## SOILS EVALUATION

**Record Number:** EHU-04-25-0356

This soils evaluation is intended for Short Plat subdivision 2450.58.  
The proposed lot number is 1 of 4.

Site Evaluation & Soil Report for Lot 1 @ Parcel Number: EH1315001

Design:	25-017	Date:	4/28/2025
Drawing:	2	Scale:	1" = 150'

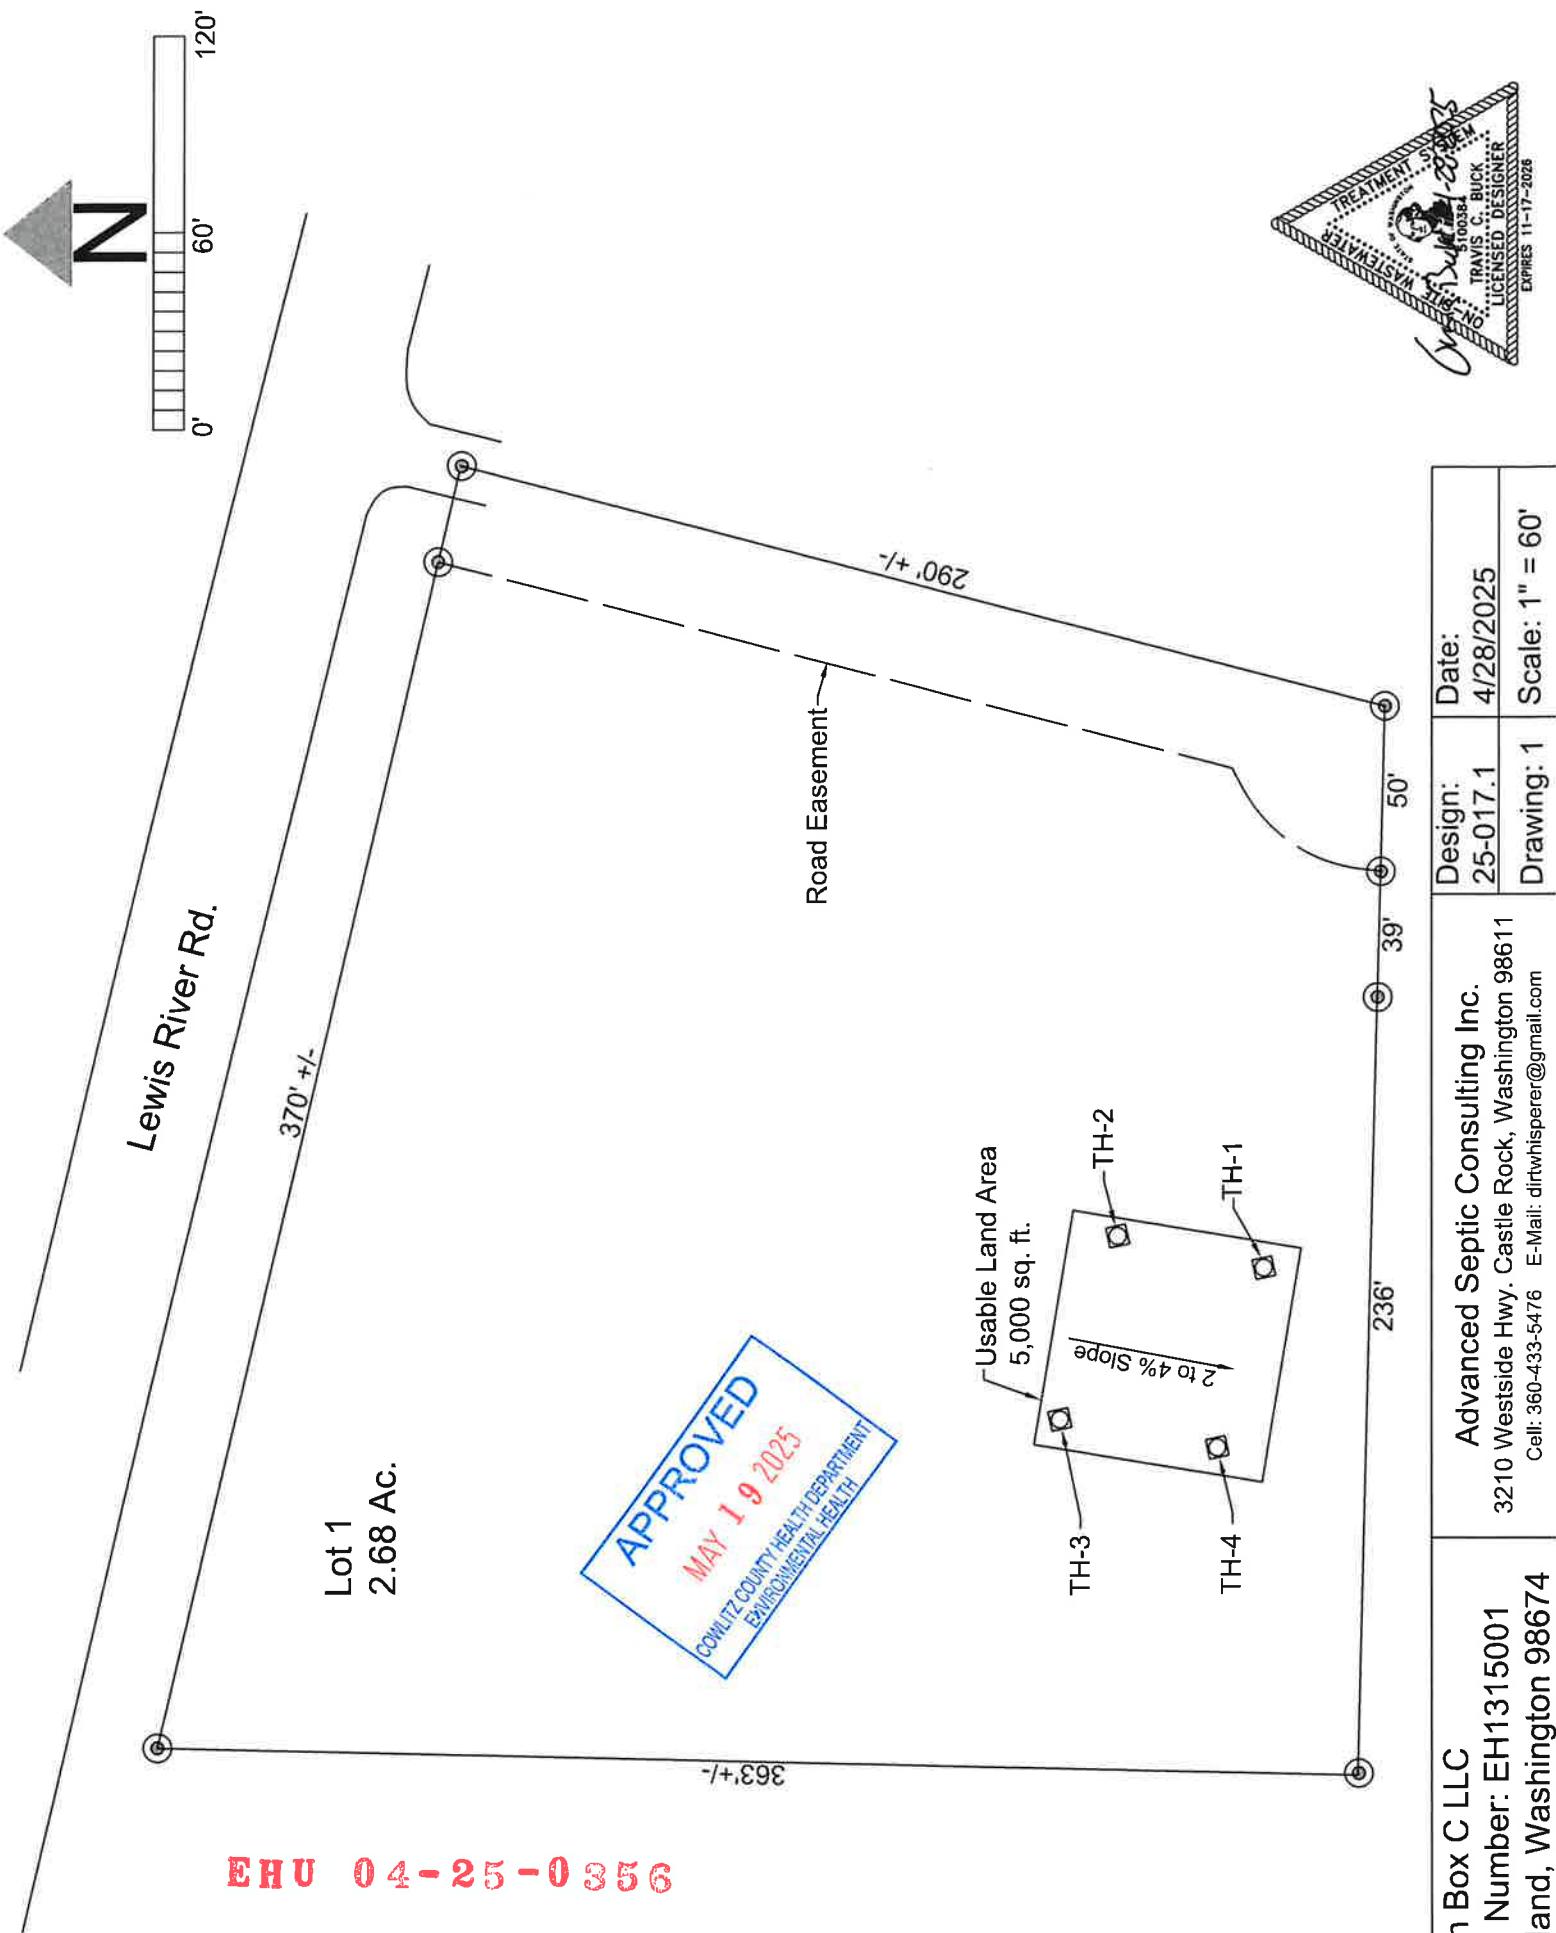
**This site appears to be able to, at this time, support an OSS as proposed.**

Approved Soil and Site evaluations are valid for five (5) years from the approval date. The proposed septic primary and reserve area(s) set-aside for future septic use must be protected from grading, fill, compaction, or any other alteration that may change soil characteristics. Soil and Site evaluations may be invalidated if the proposed septic area(s) are not protected.

For future well construction: When drilled, the well must maintain a 100' setback from the approved, proposed primary and reserve septic areas or new test holes will need to be opened and evaluated.
